# TECHNICAL SERVICE BULLETIN

**REF.:** AUDIO  
**NO.:** AU92-002  
**DATE:** AUGUST 14, 1992  
**MODEL:** ALL MODELS

## 74100 PANASONIC CASSETTE PLAYER WON'T PLAY

### Panasonic 74100

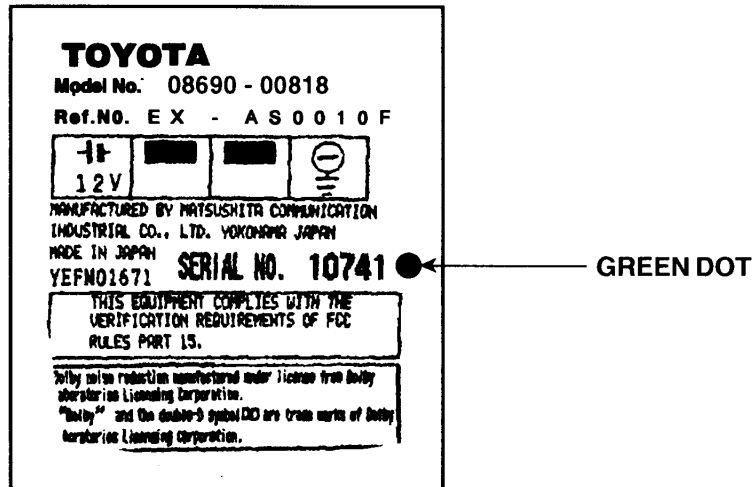
Cassette will load, fast forward/rewind and eject, but will not play on Panasonic 74100 cassette player (P/N 08690 – 008818). The motor is operating, but there is little or no audio output.

Gear mechanism which controls the tape head becomes inoperative, preventing the tape head from contacting the cassette tape.

The gears controlling the tape head have been changed to improve durability.

If a customer complains of this condition, exchange the cassette player through Panasonic's exchange system.

Exchange units have been countermeasured starting 12/91 and will have a **GREEN DOT** after the serial number.
